Access Compliance Report

Public Rights-of-Way

(Curb Ramps)

Intersection ID: 5832	Main Street: N_TRYON_ST	Cross Street: KEN_HOFFMAN_DR	Location:	N
ADA ID: 0D9324C7D5EB	Ramp Type: Combination2	Initial Pass/Fail: Pass	Overall Compliance: No	Severity Score: 7.5

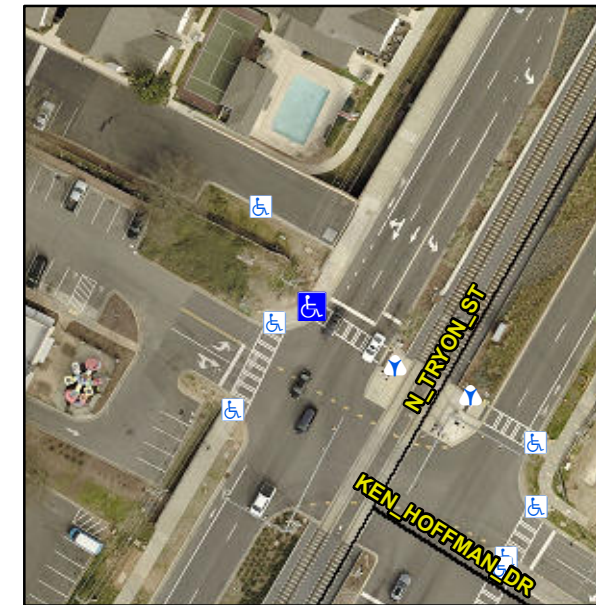
Grind Gutter Lip.

R302.7.2
